**PLANNING APPROVAL,
PLANNED UNIT DEVELOPMENT,
REZONING &
SUBDIVISION STAFF REPORT****Date: November 6, 2014****NAME**

McGill-Toolen High School

McGill-Toolen High School Subdivision, Phase Three

DETAIL SITE PLAN

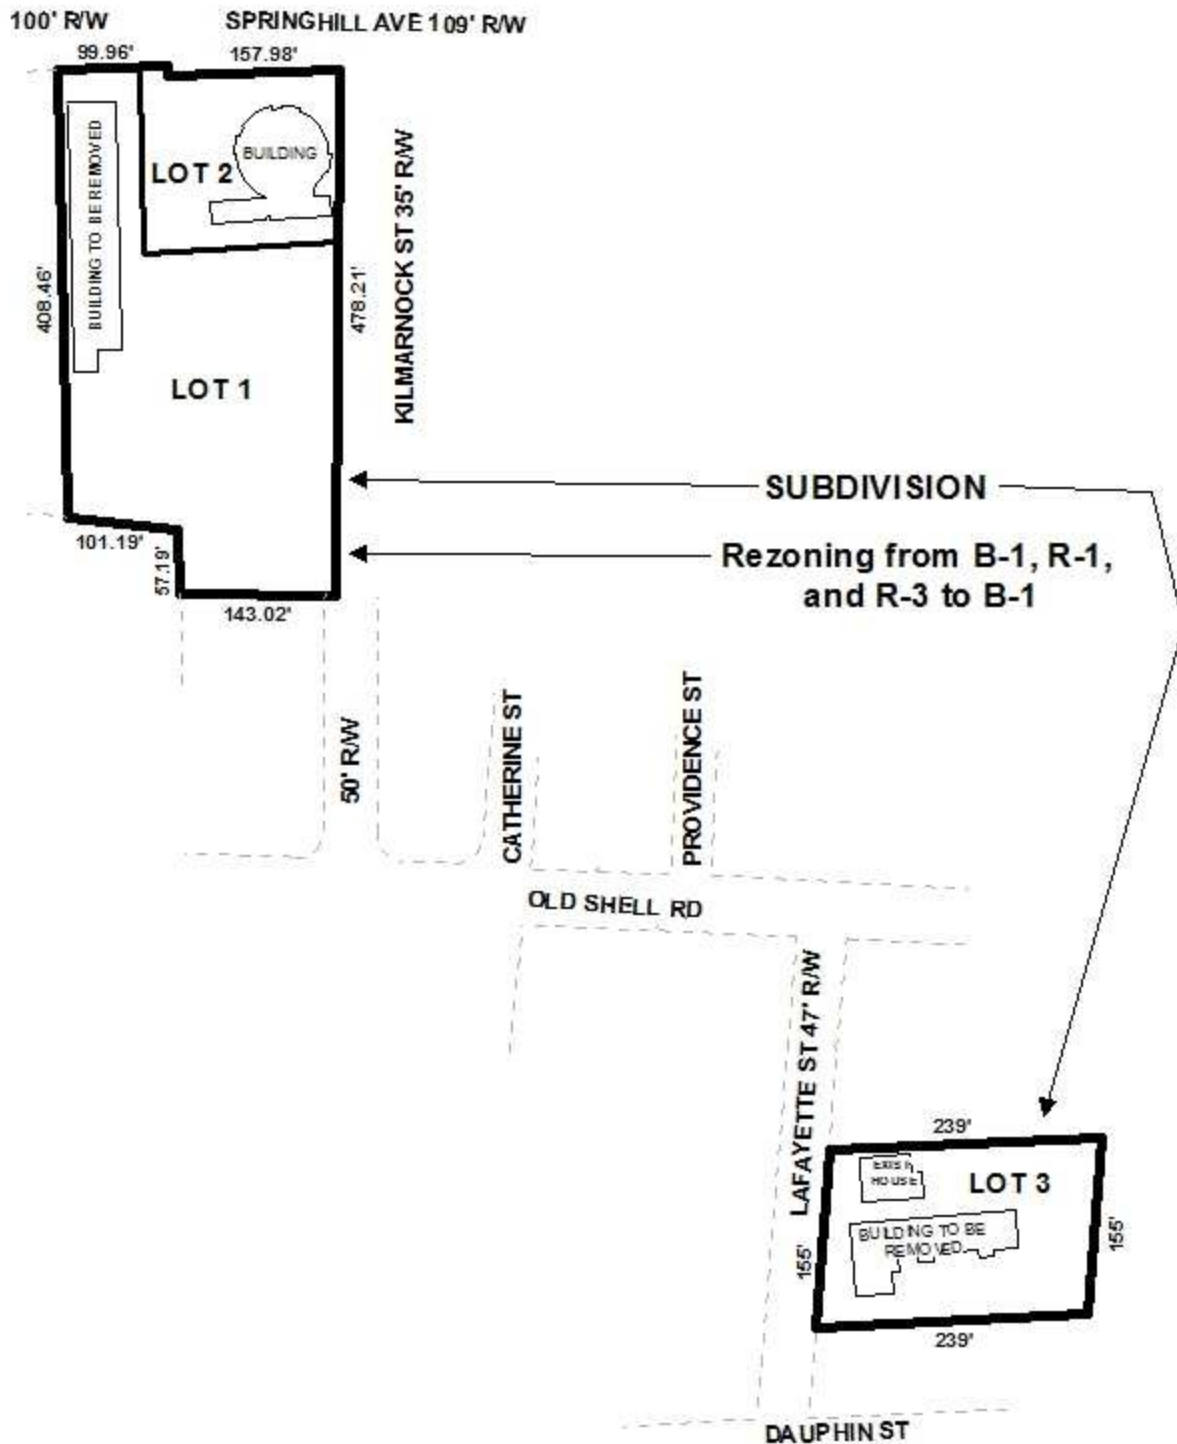
With regard to the Planning Approval and PUD site plans, there are no calculations given for the required number of parking spaces based upon the student count and no number given for the total existing spaces. High schools require one parking space for every four students. The applicant's web site profile for 2013-2014 indicates approximately 1180 students enrolled in grades nine through twelve which would require approximately 295 parking spaces. Staff's count of existing parking spaces shown on the site plans indicates approximately 394 spaces. There are 283 new parking spaces stated as proposed. This would give a total of approximately 677 parking spaces. The exact number of existing parking spaces shown is hard to determine because the configuration of the spaces along the South and East sides of the large grass field on the North side of the main campus is different from what is indicated on aerial photographs. And the exact number of proposed parking spaces given (283) is different from what is indicated graphically by count on the site plans (278). There are 66 new spaces stated and 61 graphically-

indicated within the proposed Lafayette Street expansion. None of the existing parking directly North of the field house is indicated, and the site plan indicates an existing building in that area which actually does not exist. And none of the existing nose-in/back-out parking along the West side of North Lafayette Street is indicated. The site plans should be revised to give the actual enrollment and calculated required parking spaces, the actual configuration and number of all existing parking spaces and buildings, and the actual number and configuration of proposed parking spaces. The numbers for the total parking spaces proposed after the parking expansions should be after any required revisions to the site plans.

It should be noted that there is no scale indicated on the site plans, and no scale could be graphically-determined. Therefore, revised site plans should be drawn to a given scale. Pertaining to revised site plans, both North Lafayette Street and Kilmarnock Street are of substandard right-of-way along the subject sites. As dedications will be required via the Subdivision, the site plans should be revised accordingly. And as full compliance with the buffering, tree planting and landscaping requirements of the Zoning Ordinance will be required, the site plans should be revised to indicate such, to include a 6’ high wooden privacy fence along adjacent residential sites, frontage and perimeter trees and parking trees.

Other aspects of the site plans have been revised to satisfy shortcomings found on the original site plans. The site plans are drawn to a given scale, parking calculations are provided, all existing and proposed parking spaces are indicated with corrected numbers, and revisions required by Traffic Engineering have been made. Primarily, the access to the expanded parking area on the East side of North Lafayette Street has been revised to utilize the two existing curb cuts and have internal access to the new parking area. In the Northwest expanded parking area, the curb cut to Spring Hill Avenue has been revised to accommodate right-in/right-out traffic as opposed to the right-out only which was originally allowed. Some of the Northern-most parking spaces in that area have been eliminated to allow traffic queuing on site after turning in from Spring Hill Avenue.

- 1) submission to and approval by Traffic Engineering of a Traffic Impact Study (TIS) and revision of the site plan as required by the TIS;
- 2) revision of the site plan to indicate any revisions required by the Subdivision conditions and the Traffic Impact Study;

- 3) retention of the note on the site plan stating that the existing curb cut to the existing house on North Lafayette Street is limited to residential use of the house and not to be used for access to the student parking area to the rear;

- 4) placement of a note on the site plan stating that the curb cut on Lot 1 to Spring Hill Avenue is limited to right-in/right-out traffic with the specific design of the driveway to be coordinated with Traffic Engineering, ALDOT, and the Mobile Fire Department to meet access requirements;

- 7) revision of the site plan to illustrate a 6' high wooden privacy fence along all adjacent residential properties, dropping to 3' high within the first 25' from a front property line;
